ALERT SERVICE BULLETIN

NO. 427-09-29
DATE Oct 19, 2009
PAGE 1 of 7

MODEL AFFECTED: 427

SUBJECT: TAIL ROTOR DRIVESHAFT HANGER BEARING BRACKET P/N 427-044-223-101, REWORK OF.

Figure I

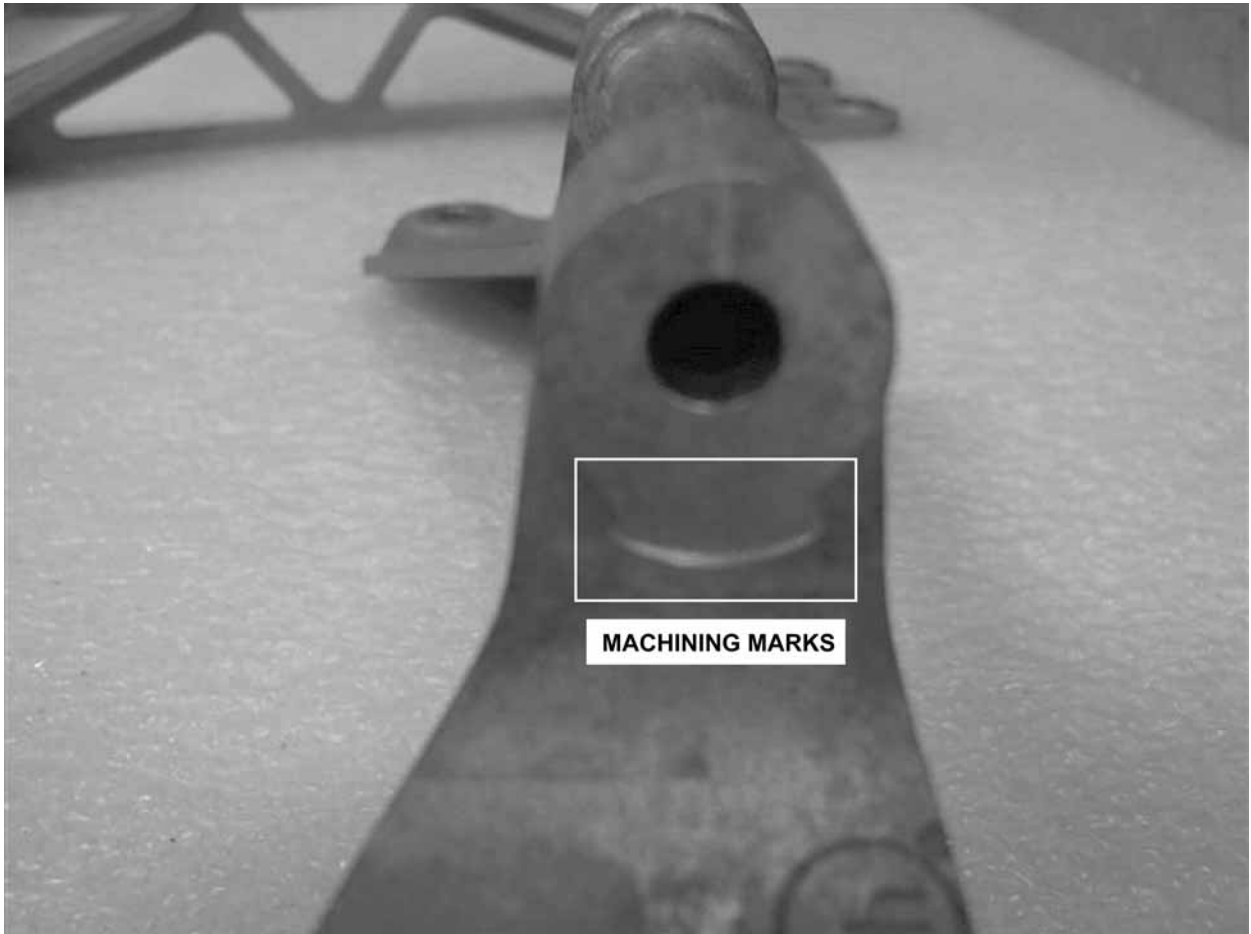
Bell Helicopter received a report of a broken tail rotor driveshaft hanger bearing bracket P/N 427-044-223-101. Investigation revealed that the part fractured due to fatigue. The crack originated in the radius near an area where a tool had cut into the bracket for a flat faying surface. Refer to Figure 1 for details.

Machining marks on bracket P/N 427-044-223-101

This Bulletin introduces a one time inspection of the bracket and provides rework procedures for the polishing of both sides of the bracket. The rework will eliminate the tooling marks and increase the fatigue strength to reduce the potential for cracking in service.

Figure 2

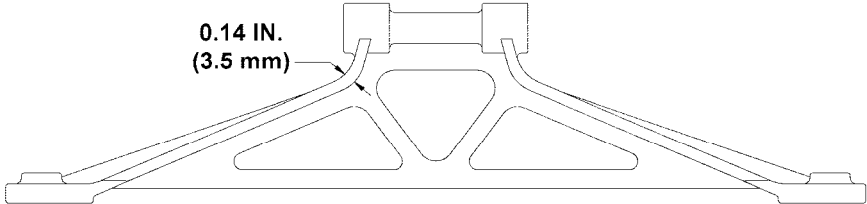
7. Rework both side of bracket P/N 427-044-223-101 as follows:
 - a) Using 180 grit sand paper, polish out the noted machining step smooth with the adjacent surfaces. Remove minimum material needed to remove the machining marks in the radius area. Maintain existing 0.50 radius and minimum web thickness of 0.140 inch. Refer to Figure 2.

- b) Polish reworked area using 280 grit sand paper. Final polish smooth reworked area using scotchbrite (C-407).
 - c) Apply chemical film material (C-100) to reworked areas. Refer to BHT-ALL-SPM. Refer to Figure 3.
